ADDENDUM NO. 1

PROJECT NAME: Vasco Caves Regional Preserve (Byron Vernal Pools)
Souza II Wetlands Restoration Project, Byron, CA

CONTRACT NO: 05-09-140

Downed Utility Poles, Southern Access Route and Barn Location
 VASCO CAVES REGIONAL PRESERVE (BYRON VERNAL POOLS)
 SOUZA II WETLANDS RESTORATION PROJECT, BYRON, CA
 PROJECT NO. 145400 / CONTRACT NO 05-09-140

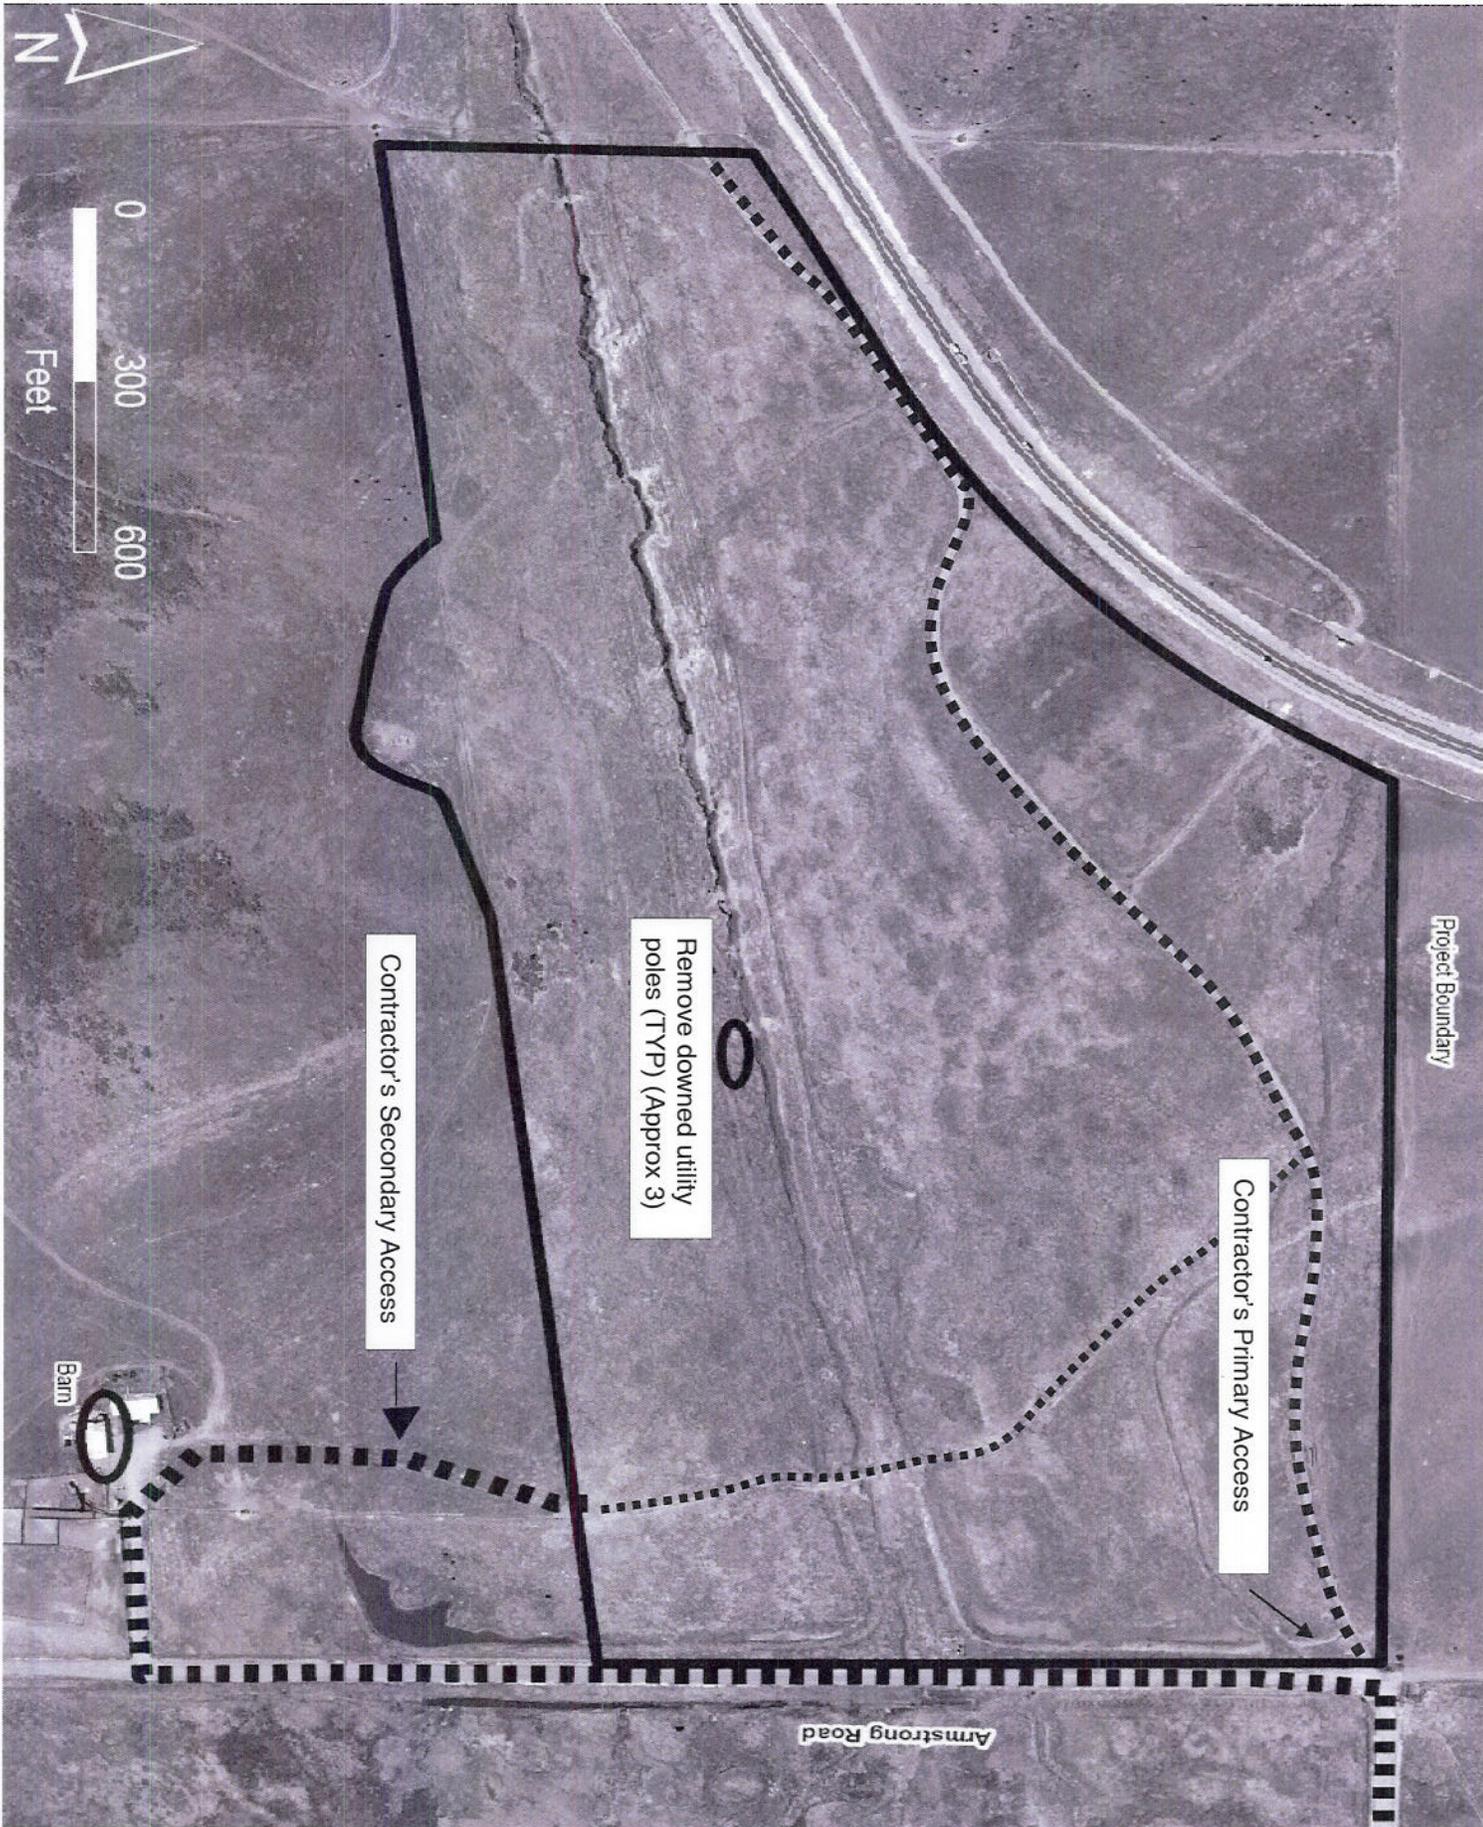
Remove abandoned well (approx. 9" diameter, approx. 12" exposed above grade, depth of well is approx. 15'-0" below grade).
- Item #3:** Plans, Sheet G-4: Add additional downed utility poles to be removed during demolition. See attached drawing A-1 sheet 1 for approximate location.
- Item #4:** Plans, Sheets SA-1 and G-5: Add additional contractor access point from south side of site. See attached drawing A-1 sheet 1 for approximate location.
- Item #5:** Plans, Sheet D-2, revise Detail 2 : See attached drawing A-1, sheet 2.
- Item #6:** Specifications, Division 05, Pond Construction, page 1: Delete reference to 1/16" diameter steel geotextile pins for anchoring geomembrane barrier.
- Item #7:** Supplementary Conditions, Page 10, Delete Paragraphs 01.24.1.d. dewatering plan and 01.24.1.e.

- b. Salvaged soil material supplied by the District is located in the barn southeast of the property. See attached plan for location.

2 **GEOMEMBRANE BARRIER**
D-2 NOT TO SCALE

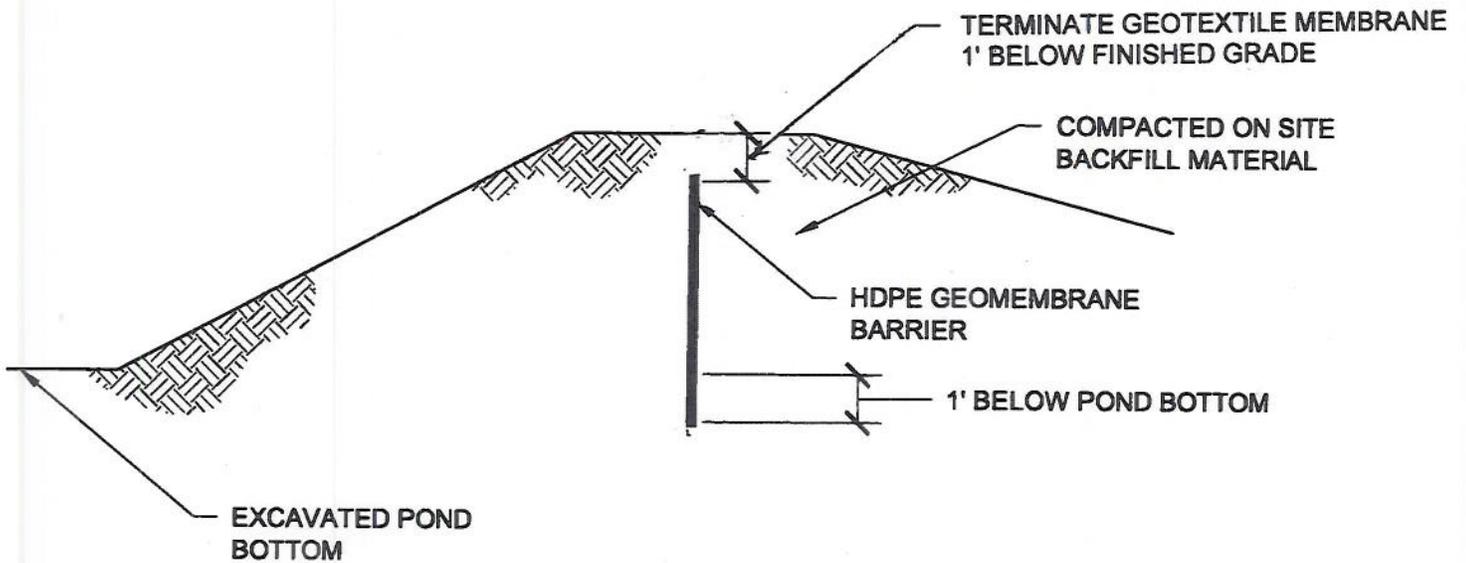
.3 Contractor shall install an HDPE geo-membrane vertical barrier in the center of the pond berm, as shown on the drawings. The membrane shall be placed a minimum of one-foot below the elevation of the pond bottom. If more than one continuous sheet of material is used, adjacent sheets shall be overlapped by a minimum of one-foot. Onsite fill material placed next to the geo-membrane shall be placed in 6" maximum lifts and compacted to a minimum of 90% relative density in accordance with ASTM Test Method D1557.

1. OVERLAP GEOMEMBRANE SHEETS BY A MINIMUM OF ONE FOOT.
